Shippensburg University

SUPPLEMENT 1 Electrical Coordination Study

Professional:
Entech Engineering, Inc.
4 South Fourth Street
P.O. Box 32
Reading, PA 19603
Telephone: 610-373-6667
Fax: 610-373-7537
www.entecheng.com
Entech Project #: 2184.22

August 24, 2004

TCC Name: 1204
Rev. 0.0
Date: March 12, 2004

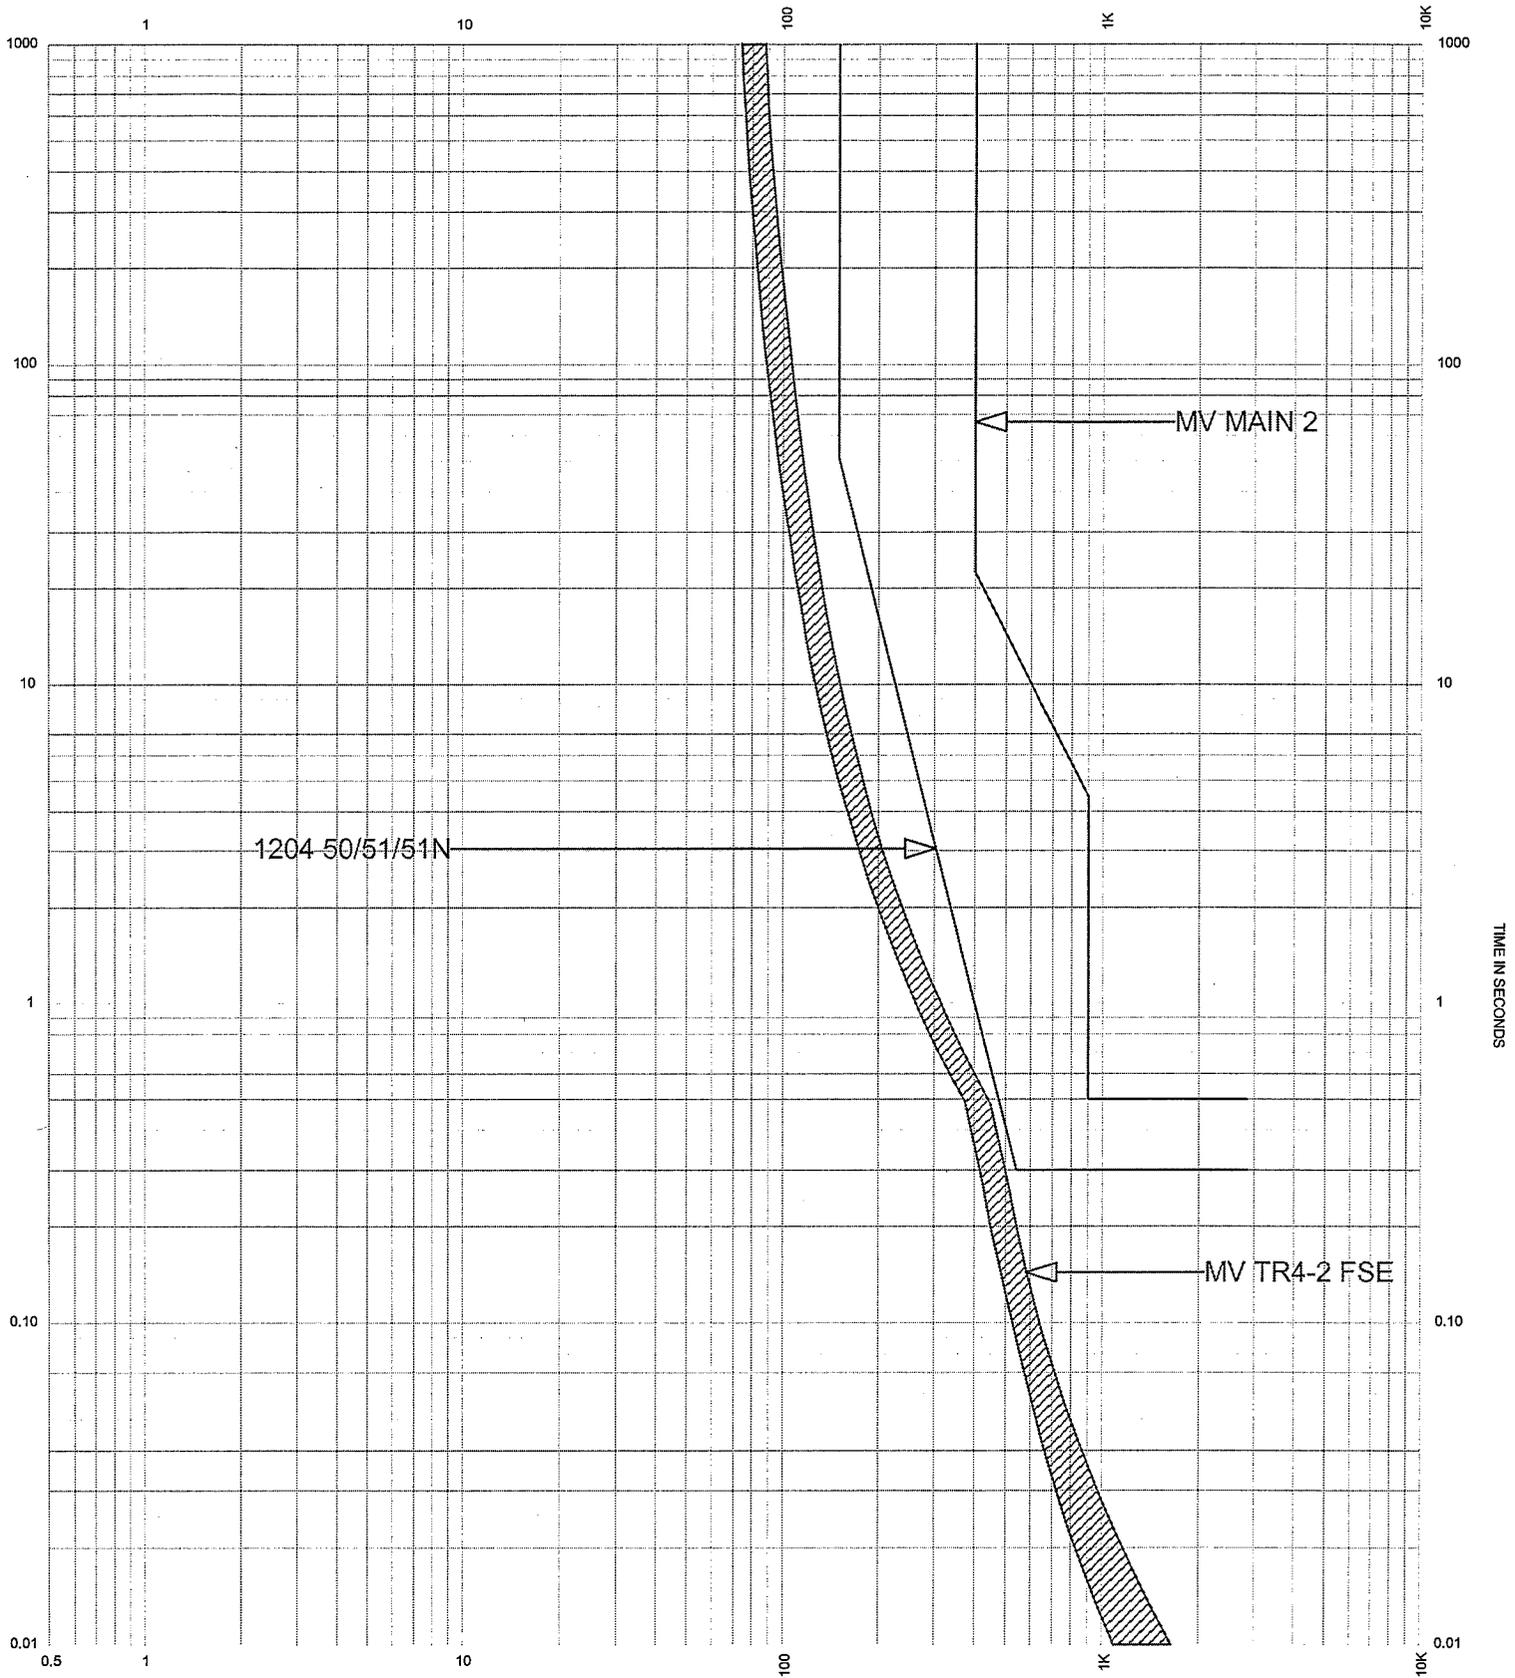
Although the coordination issues above could be corrected without resetting the main 12.47kV bus relay #1 and the feeder 1204 relay, it is recommended that both main 12.47kV bus relays have the same settings and that the feeder relays have the same settings. This will help with load balancing across all four feeders as new loads are added to the system and facilitates coordination of the tie-breaker between the main 12.47kV buses. Also, it is important to note that the recommended curve for the main 12.47kV bus relays is an I4T curve versus the original I2T curve. I4T changes one decade of current over four decades of time. This curve fits standard fuse curves more closely than the I2T curve, which changes one decade current over two decades of time.

RECOMMENDED RELAY SETTINGS*						
Setting	Main #1	Main #2	1201	1202	1203	1204
Curve	I4T	I4T	I4T	I4T	I4T	I4T
LTPU	0.8	0.8	1.2	1.2	1.2	1.2
LTD	2.25	2.25	12.5	12.5	12.5	12.5
STPU	4.5	4.5	9.0	9.0	9.0	9.0
STD	0.5	0.5	0.1	0.1	0.1	0.1
INST	25	25	—	—	—	—

TCC Name: TR1-1 McCUNE HALL
Rev. 0.0
Date: March 12, 2004

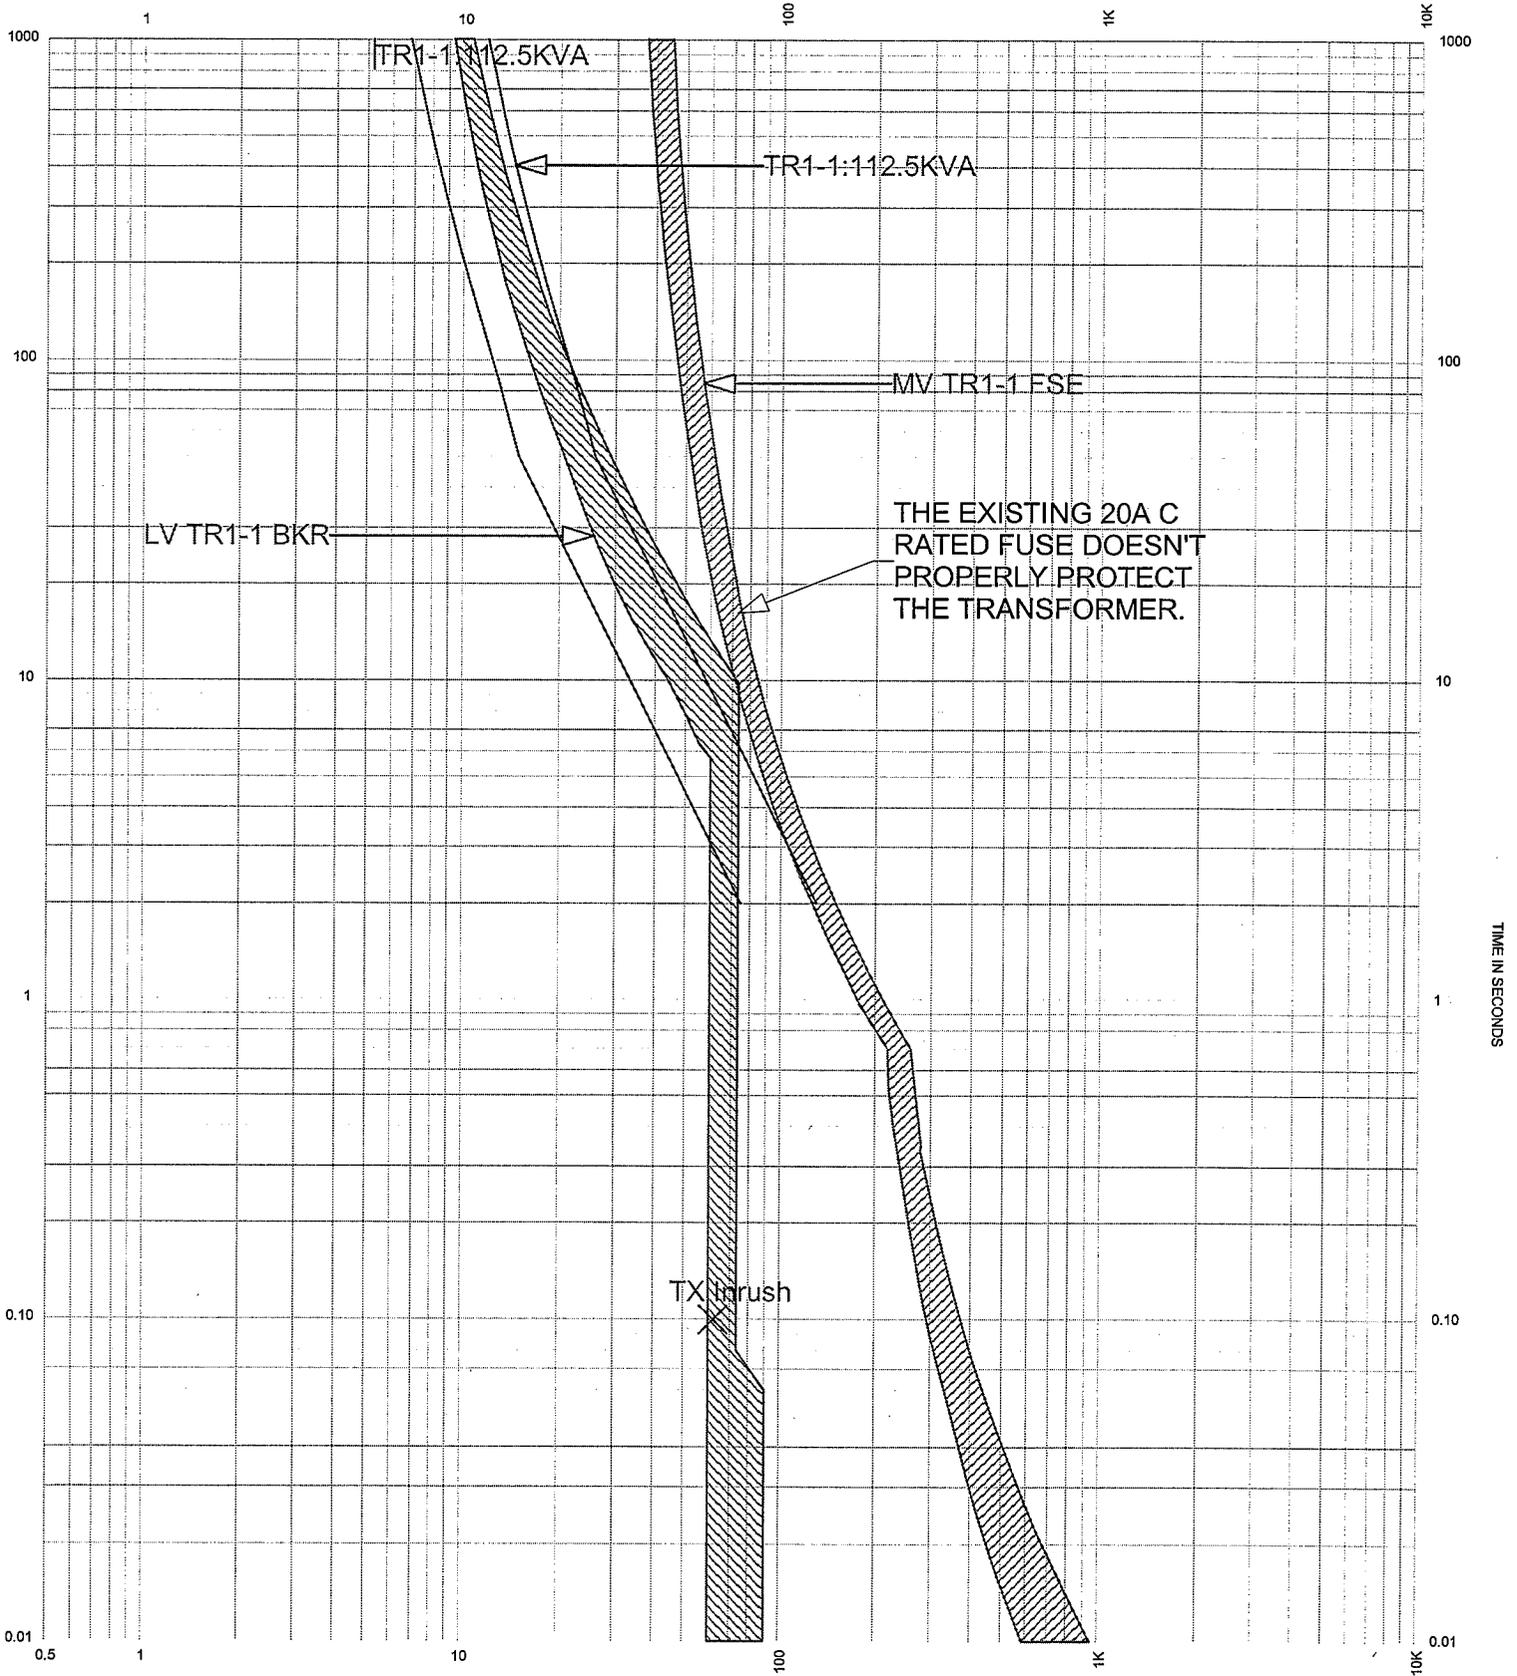
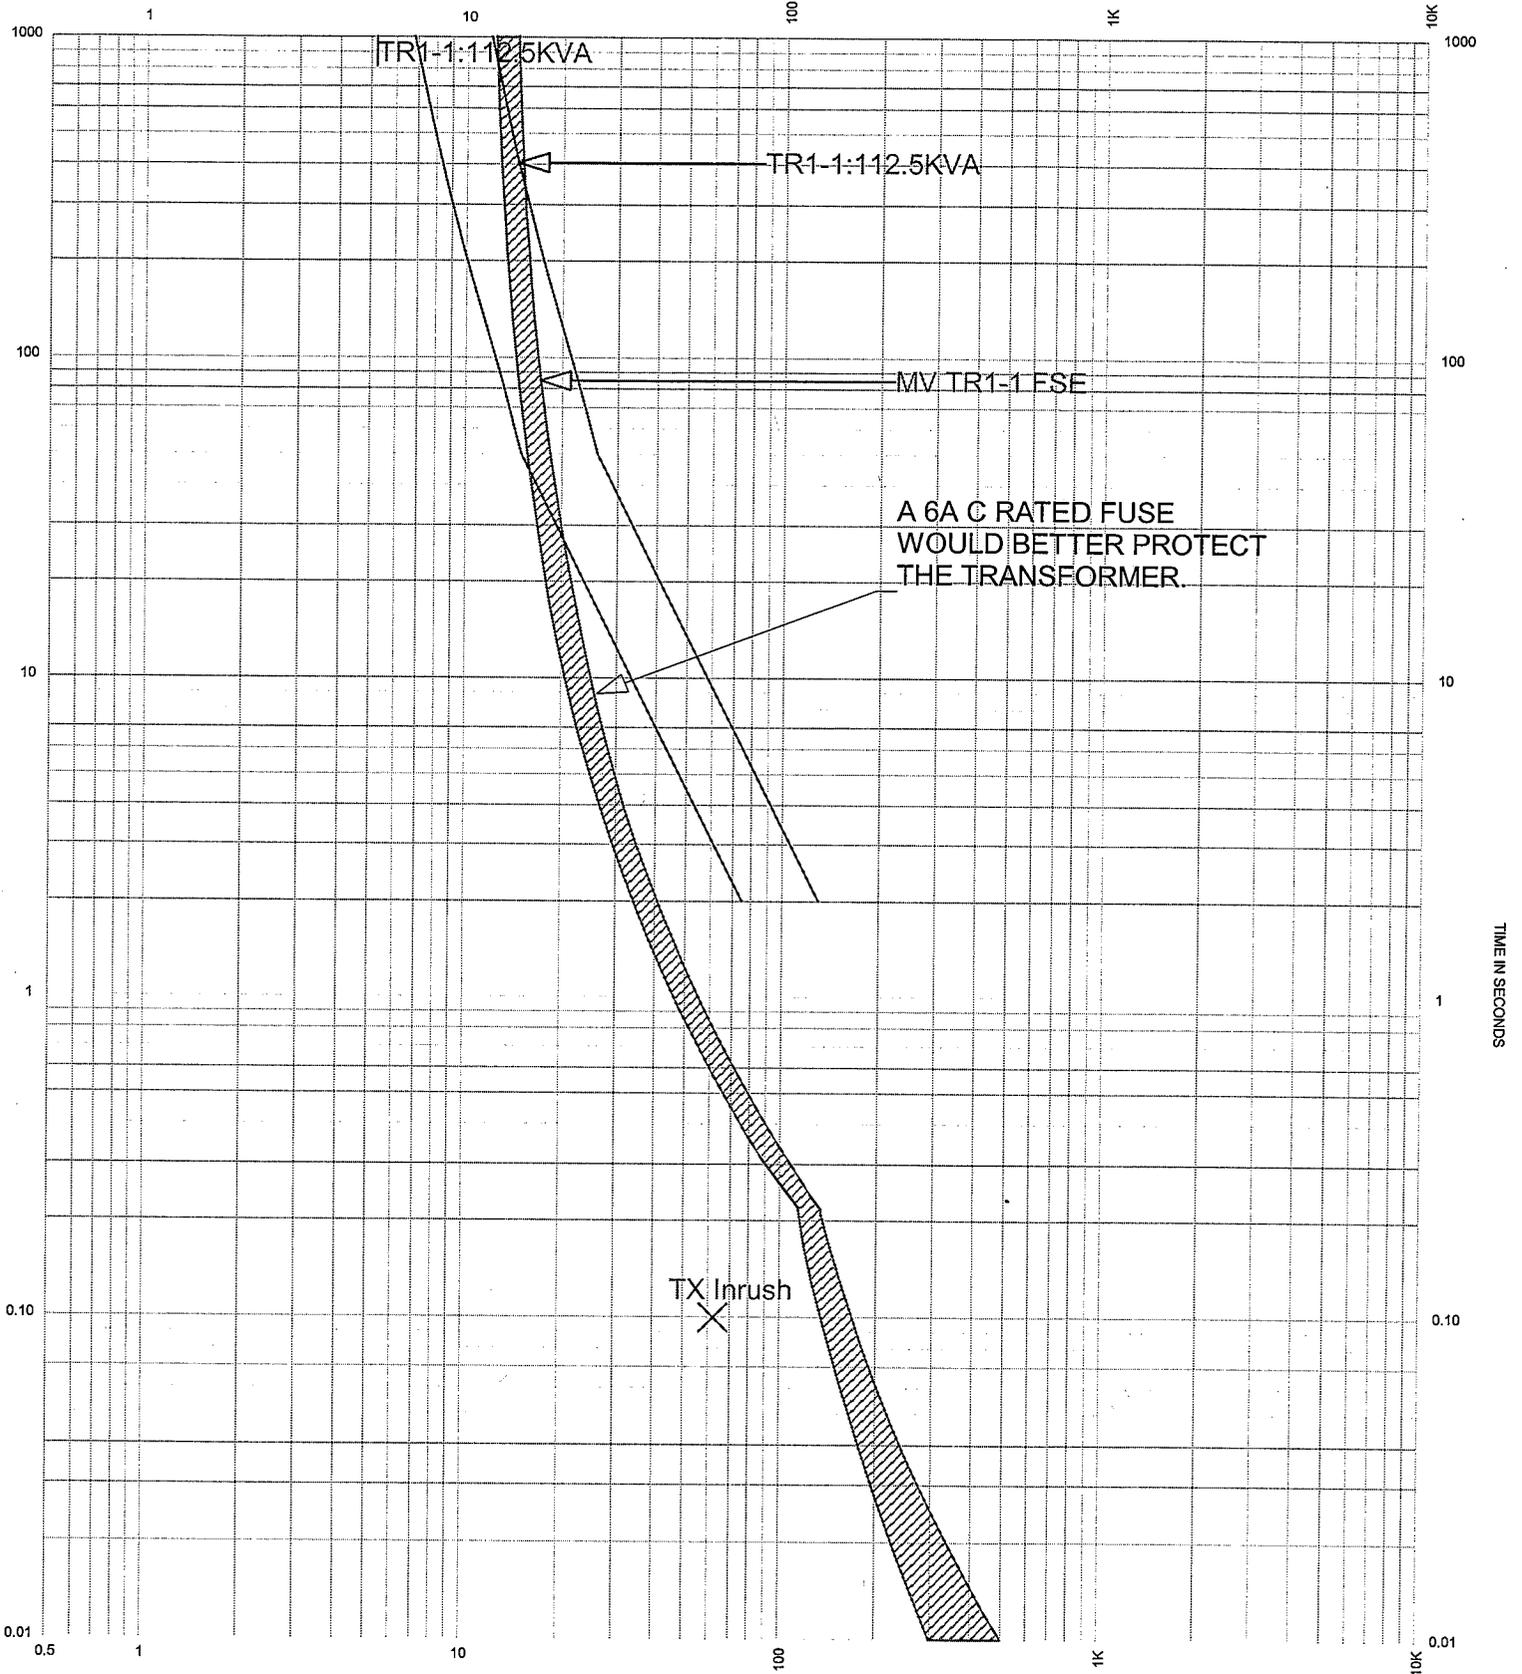
TCC TR1-1 McCune Hall: Although the primary fuses for TR1-1 and secondary main breaker are coordinated, the primary fuses do not properly protect the transformer. Using a 3A C rated fuse instead of a 20A C rated fuse would improve transformer protection (refer to TCC TR1-1 McCune Hall in Appendix B). As far as secondary protection is concerned, replacement of the secondary distribution panel should be considered based on age and configuration. A new static trip (solid state) secondary main breaker with long-time, short-time, and instantaneous pickup and delay settings is advised. This would allow greater flexibility in coordinating with the upstream primary fuses.

TCC Name: TR1-2 REED OP
Rev. 0.0
Date: March 12, 2004

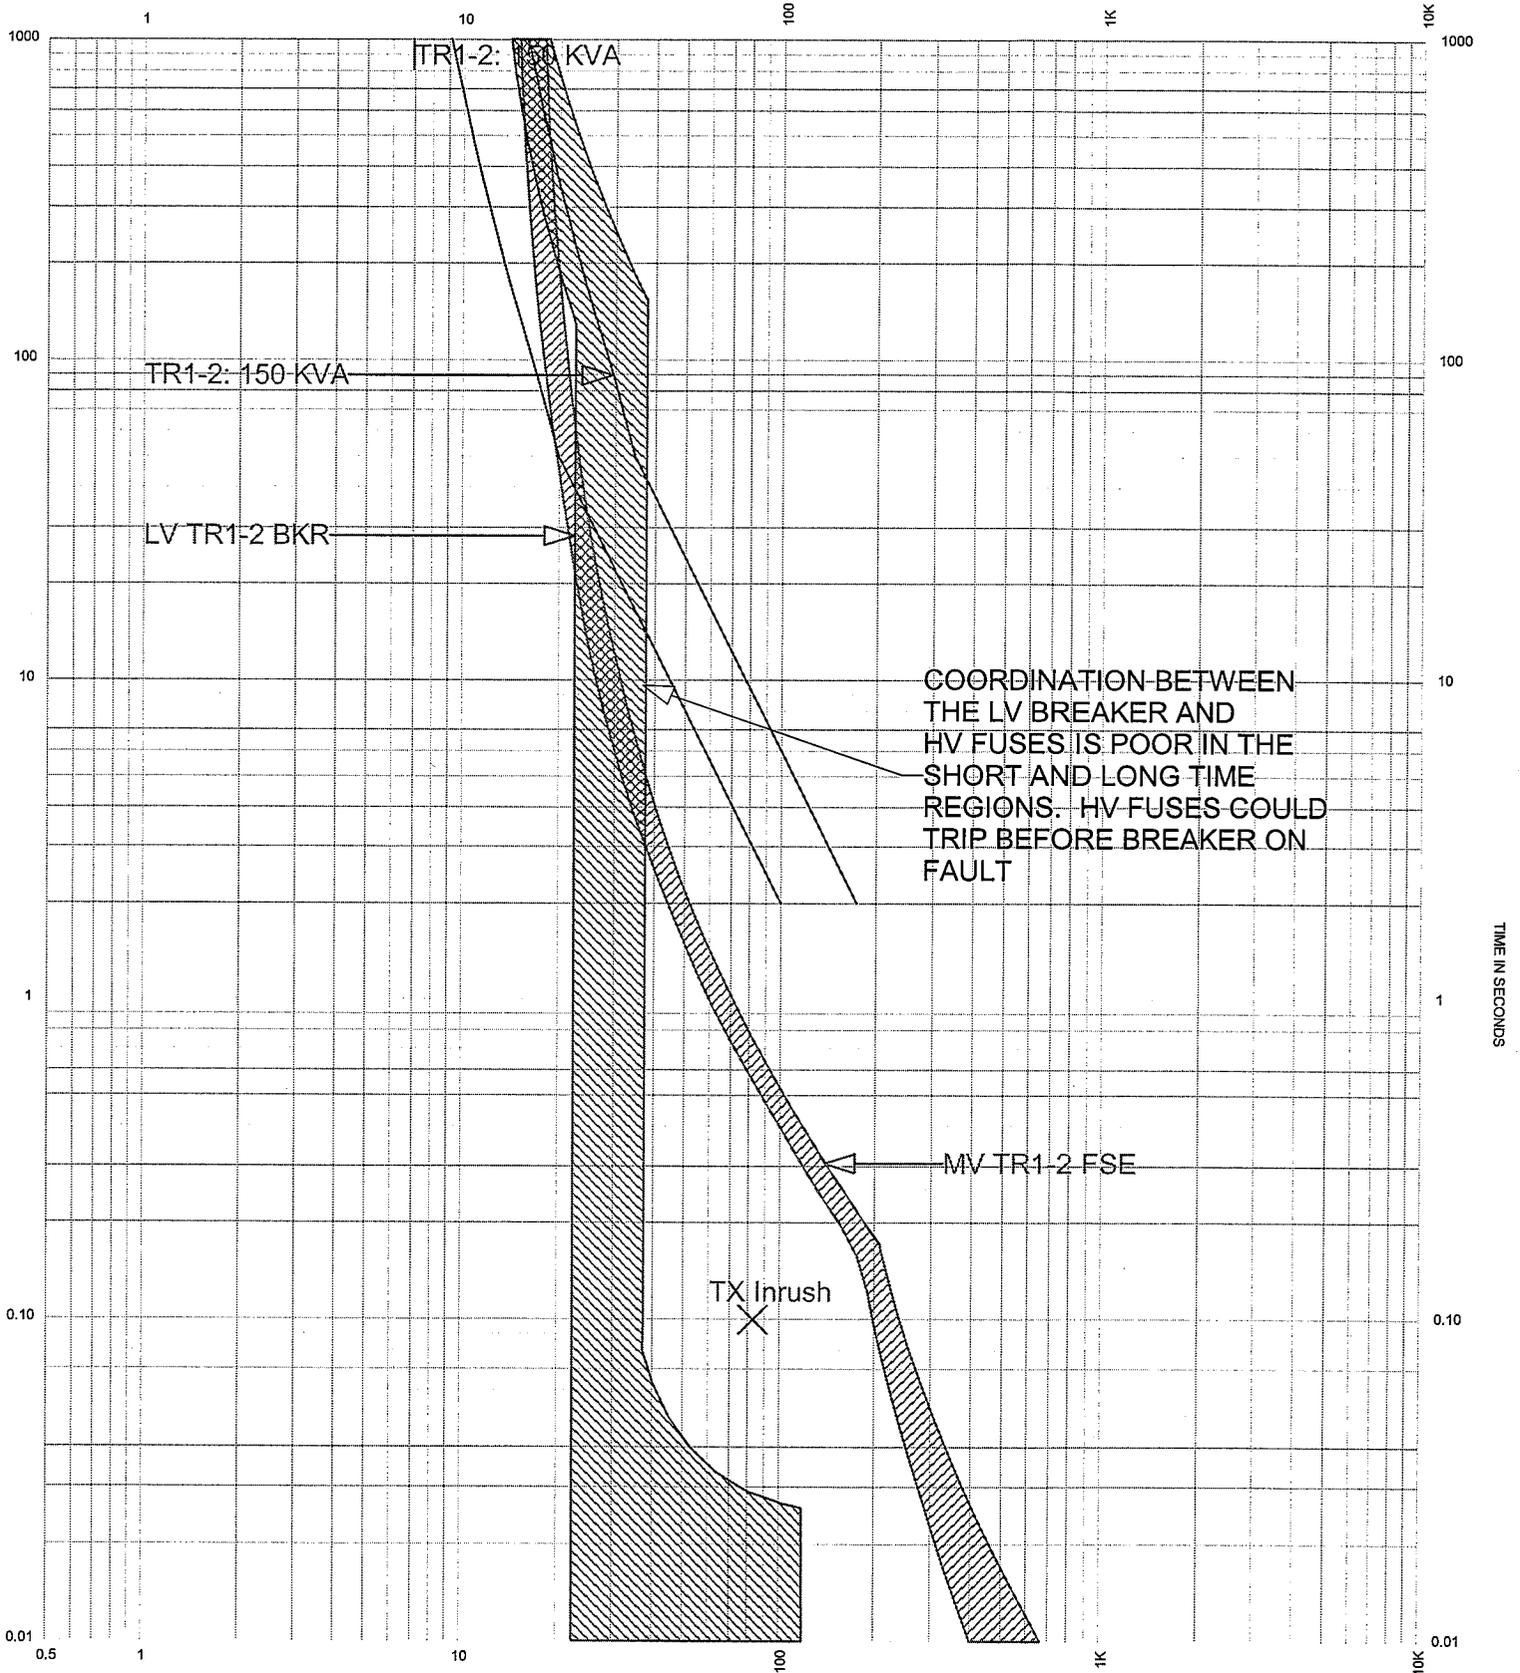
TCC TR1-2 Reed Operations Center: The existing low voltage secondary main breaker is reported to be Westinghouse 500A thermal magnetic breaker. This breaker does not coordinate well with the primary fuse. To improve coordination, the existing thermal magnetic breaker could be replaced with a static trip (solid state) main breaker with long-time, short-time, and instantaneous pickup and delay settings. However, due to age of the existing equipment, replacement of the existing unit substation and secondary distribution panel is recommended.
